**RESPONSE TO COMMENTS  
DANA HILLS HIGH SCHOOL PERFORMING ARTS  
FACILITY  
CAPISTRANO UNIFIED SCHOOL DISTRICT**

The following provides all written comments received on the Initial Study prepared for Dana Hills High School Performing Arts Facility in the City of Dana Point and the Capistrano Unified School District's (District) response to each comment.

The Planning Center • Figure 2

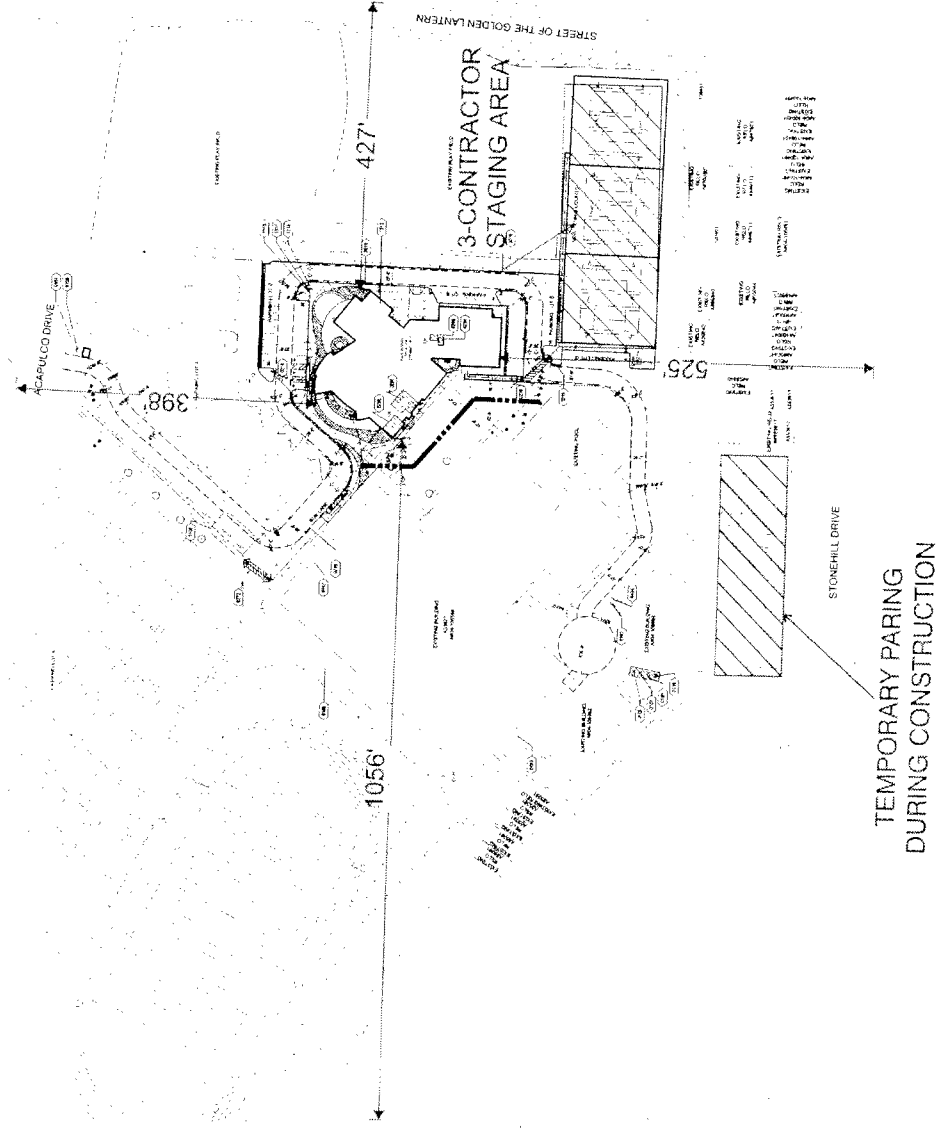
The MND does not have sufficient information on parking demand for the High School and therefore it cannot be evaluated if the site provides sufficient parking for the proposed facility in compliance with the Zoning Ordinance. The City considers it to be a significant impact. The MND needs to be revised to state that the project is not consistent with the Zoning standards of the site. | A3-7

The MND also needs to provide information on additional parking needs during the construction phase. There is no information on how or where construction related vehicles will be parked on the site during construction and any impacts it may have on regular parking demand for students, teachers, and visitors. The MND needs to show the area on-site where construction related equipment will be parked. Typically the contractors use portions of the parking lot. It seems that the school would need to use current athletic fields to accommodate construction related parking demand. A3-17

- *#8 The project site should maintain the existing on-site pedestrian access to serve the proposed performing arts theater:* The proposed project would not affect any onsite pedestrian access and, as shown in Figure 2, *Site Plan*, onsite pedestrian access is already provided. This measure has no mitigating effect, and therefore has been excluded.

- A3-16 Please refer to Response A3-15.
- A3-17 Figure 2, *Site Plan*, shows the contractor staging area. As shown, the existing parking lot would not be impacted to cause shortage in parking.
